## CMRC Clarification of Galley and Chart Table Openings on Inner Vertical Surfaces

Original Submission - 12/26/2023

CMRC Response - 2/14/2024

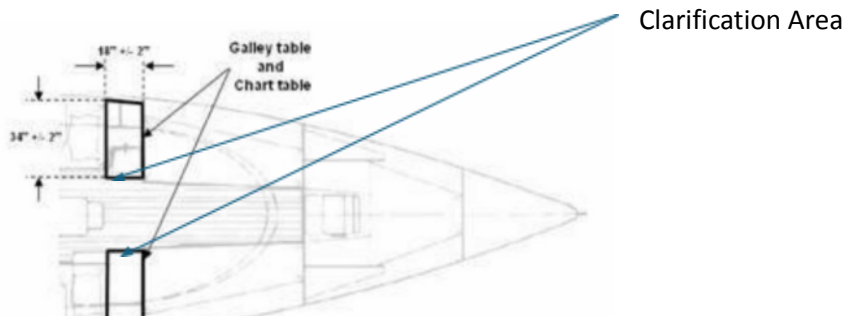
Rule 15.4.12 neglects to define the requirement of the vertical surfaces of the chart and galley table openings clearly.

Rule 15.4.12 The galley table and chart table shall be constructed of a minimum of 1/2" marine plywood. The galley table and chart table are to be located on opposite sides of the cabin. A stainless-steel sink 13 by 15 5/8 inches minimum length and width shall be installed in the galley table. The height of the sink and chart table are to be located 29 inches +/- 4 inches above the cabin sole. The galley table and chart table shall each be 18 by 34 inches +/- 2 inches. (Drawing 15.4.11)

There must be a minimum opening size of 24 x 12 inches on the galley and chart table vertical inward facing surfaces to stay true to the original design, and any material used to create this feature must be mechanically fastened, not glued or taped. 15.24.1 and .2 cover items that are not fully detailed in the rules. CRMC has identified that this is not clearly defined in the rules of today, but it is the intended design. CRMC is always working to make information of all types clearer to members, this will be included in future doc reviews for improvement.
